Carlyle/Eisenhower East Design Review Board (DRB) Application

PROJECT NAME: Carlyle Block P BLOCK: P

DESCRIBE THE REQUEST BRIEFLY: Approval to minor modifications to the previously approved design of the South Tower of Carlyle Block P.

765 JOHN CARLYLE - SOUTH TOWER

BUILDING MATERIALS - LOWER FLOORS

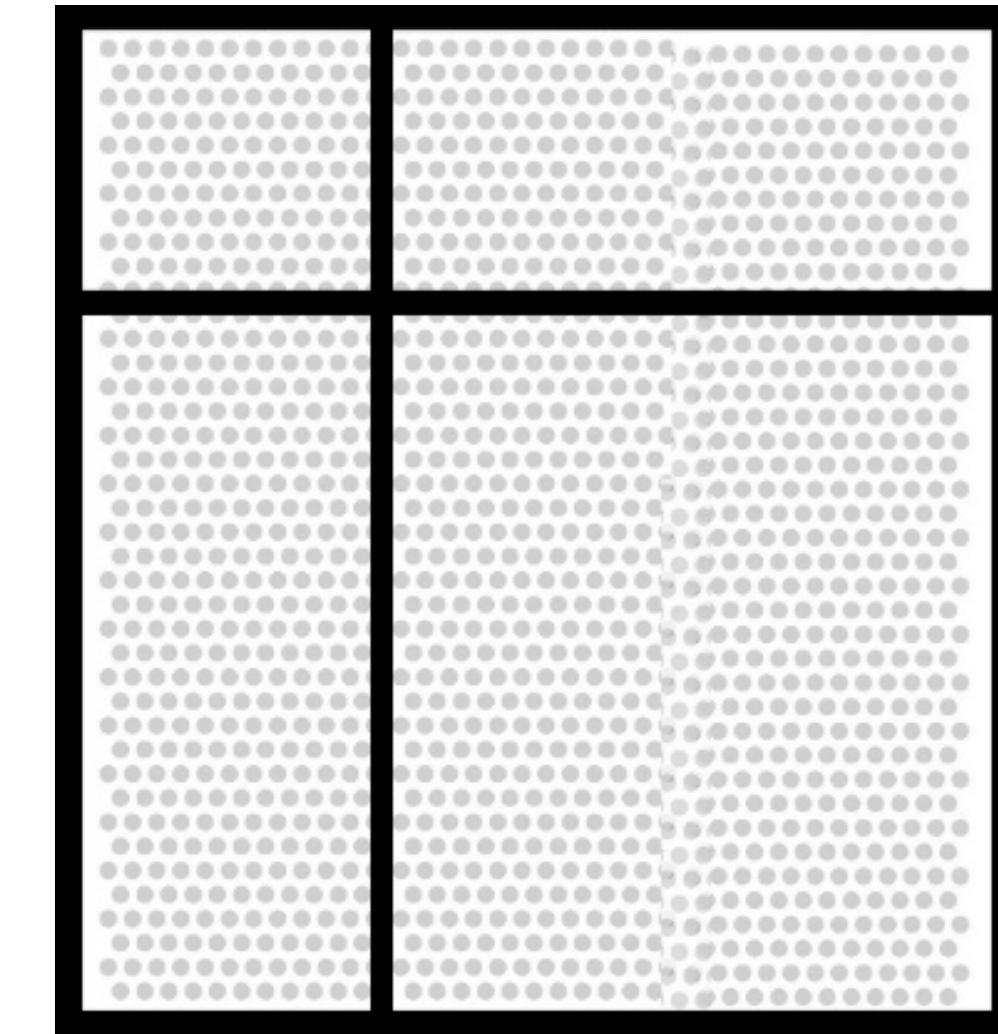
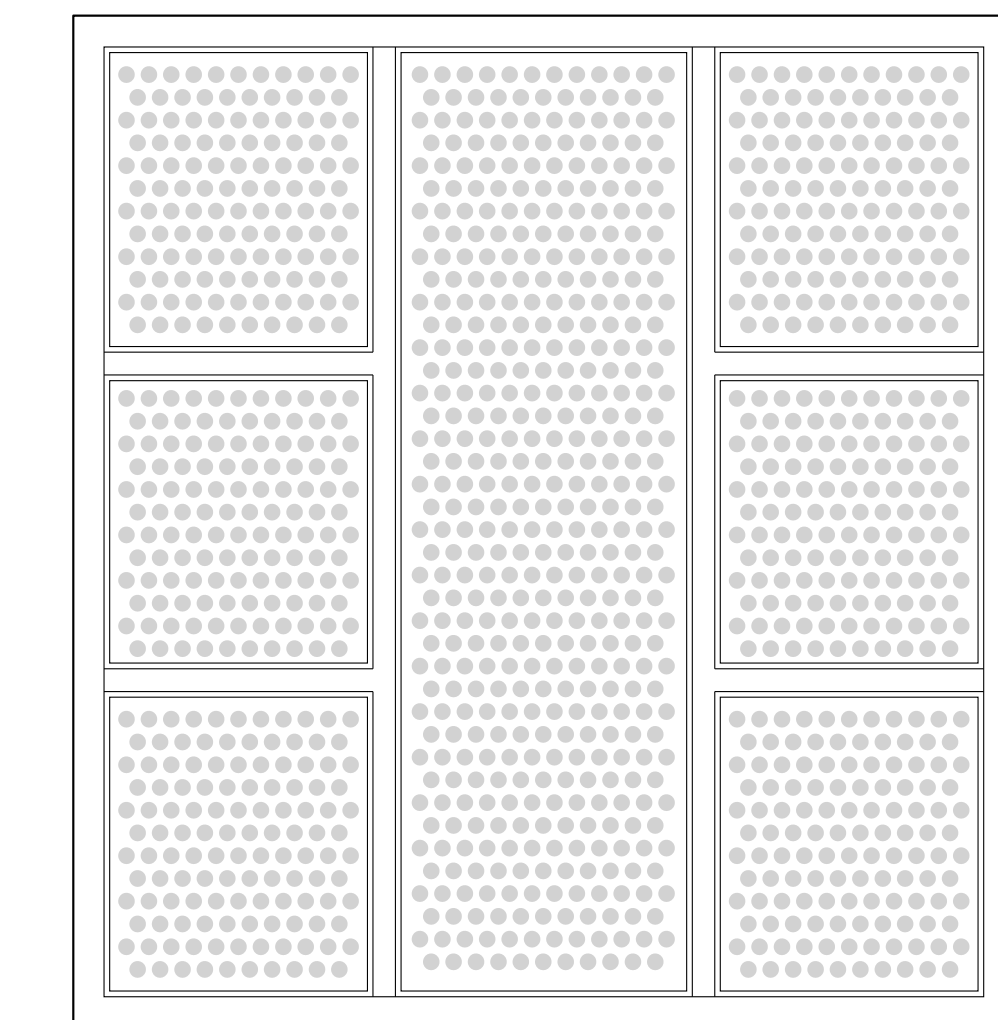
PROPOSED MODIFICATION: CHANGE WINDOW FRAME FROM MULTI-PANE TO FOUR PANE TO MATCH THE WINDOW CHANGES ABOVE

PREVIOUS APPROACH: PEFORATED PANEL PATTERN MODELS WINDOW FRAME

BUILDING MATERIALS - UPPER FLOORS

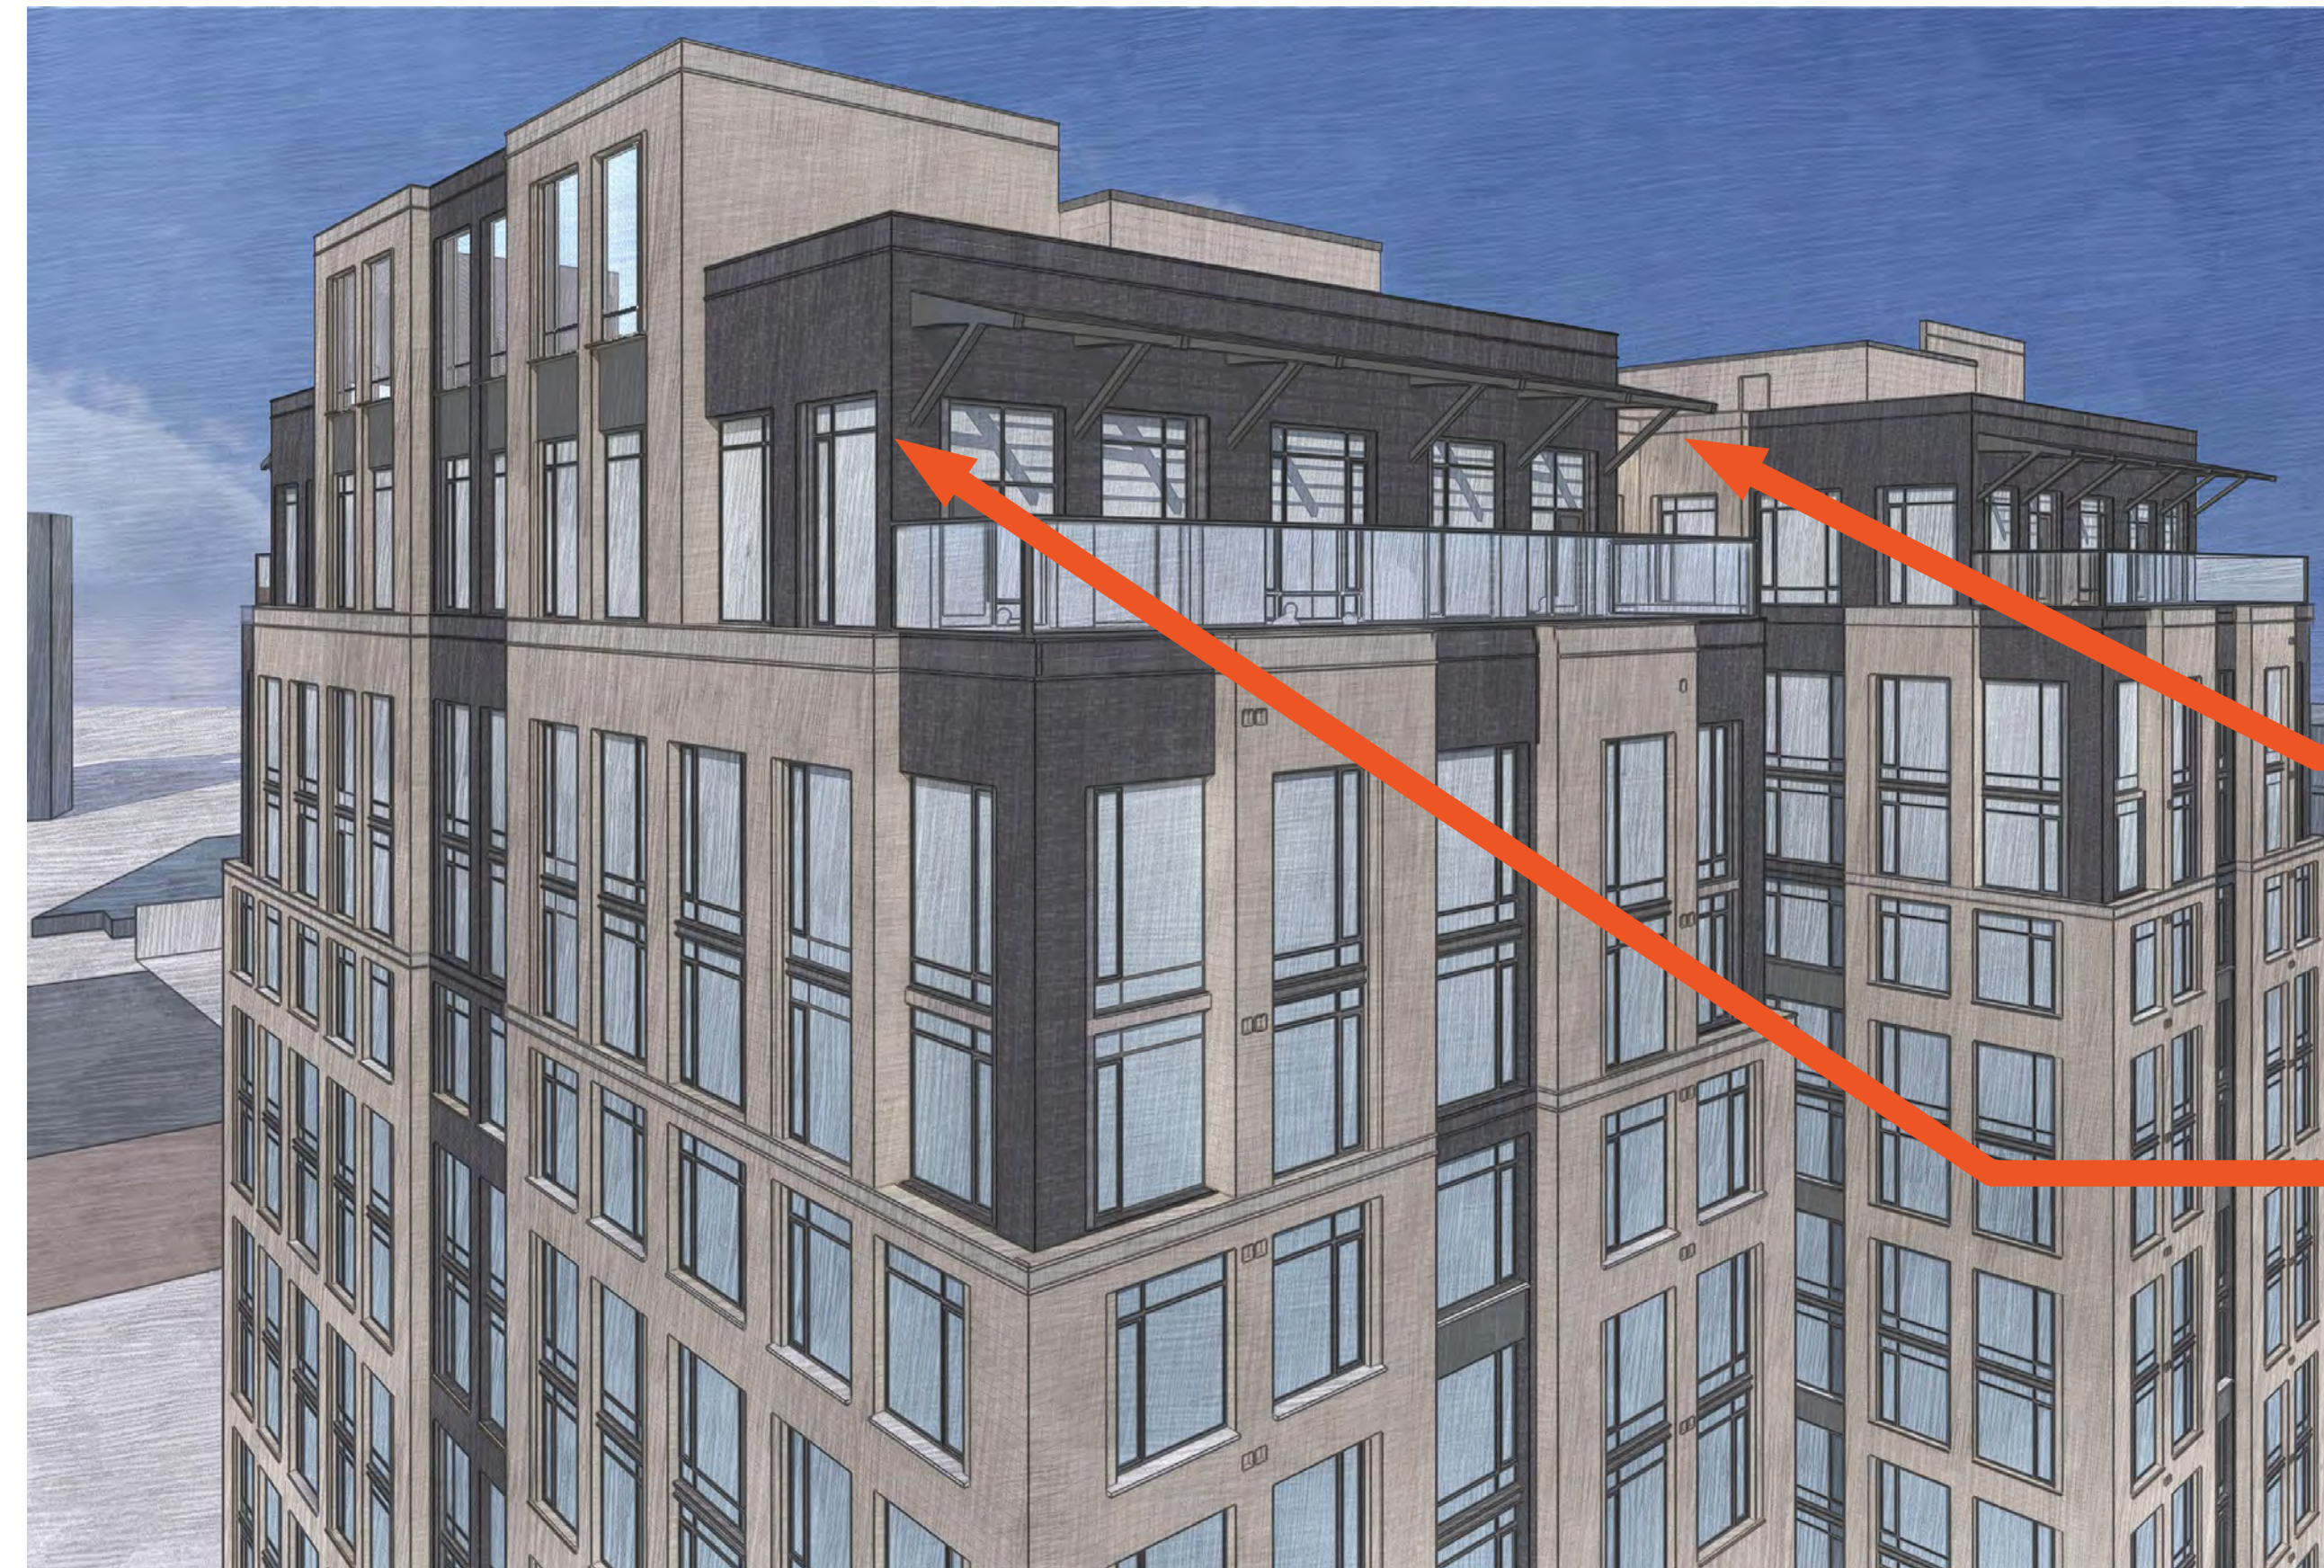
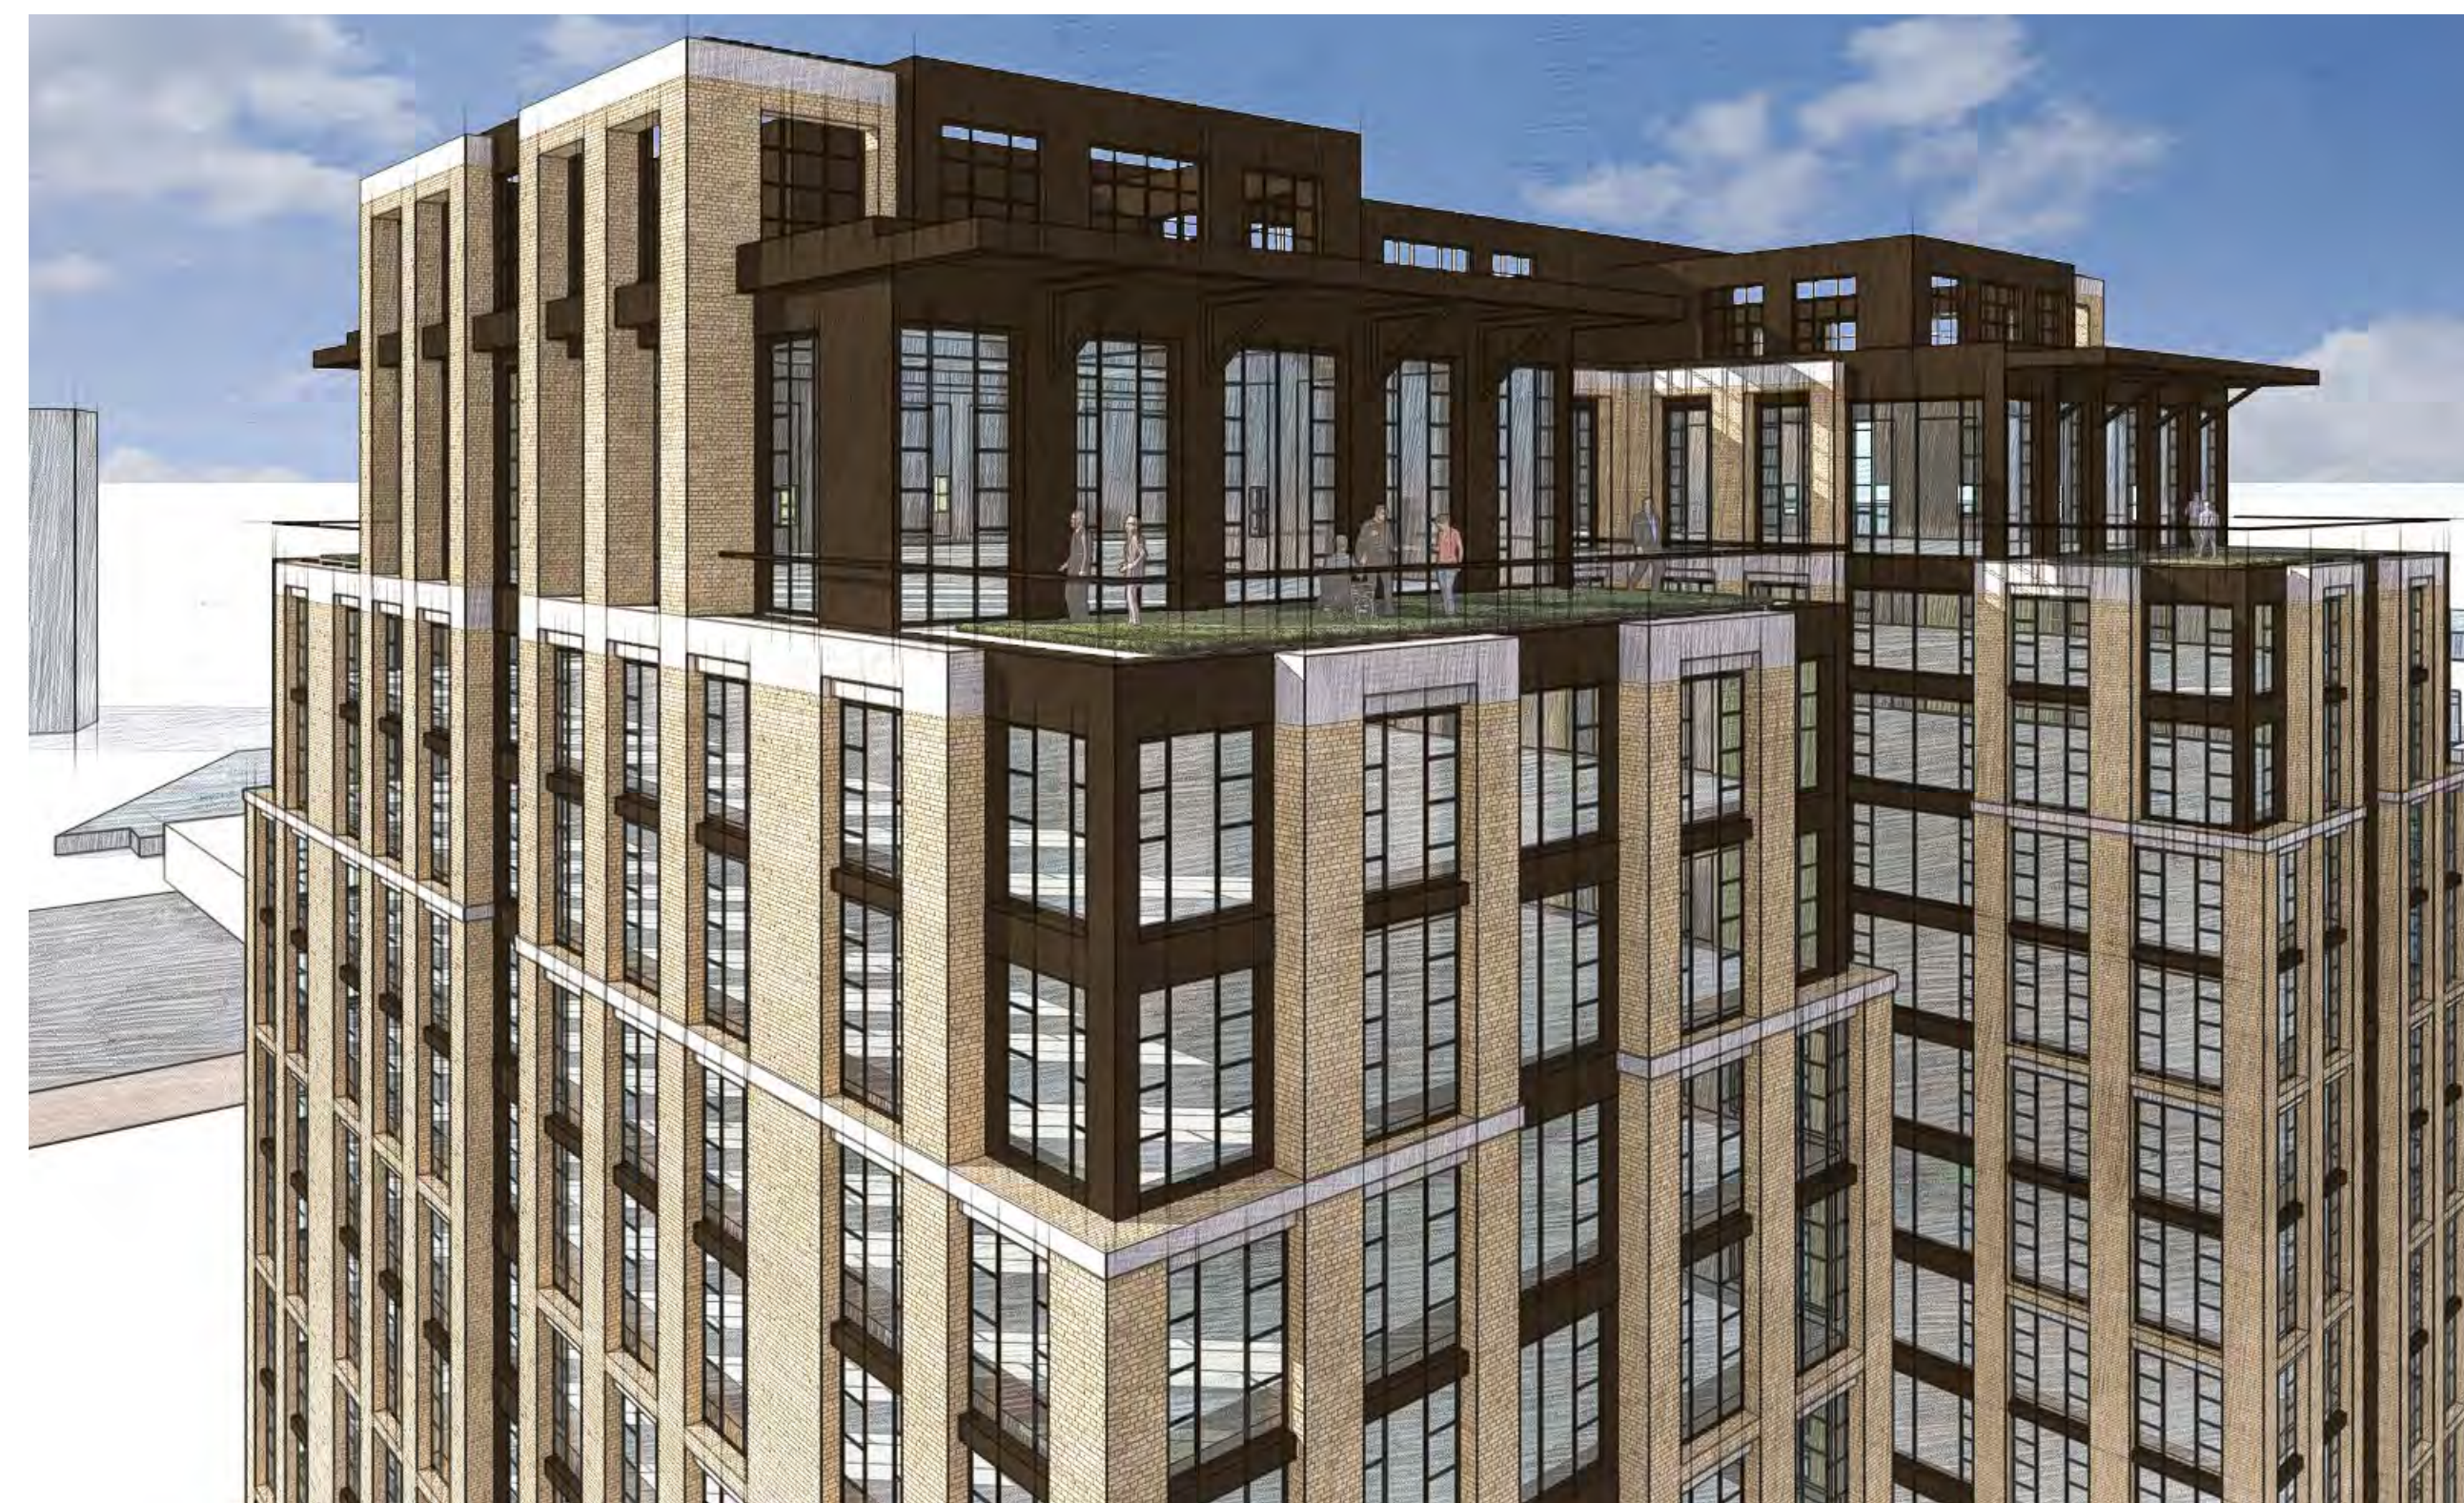
FIBER CEMENT PANEL AT MECHANICAL YARD - COLOR TO MATCH LIGHT BRICK

DARK METAL PANEL CHANGED TO DARK BRICK ON 16, 17 & 18TH FLOORS
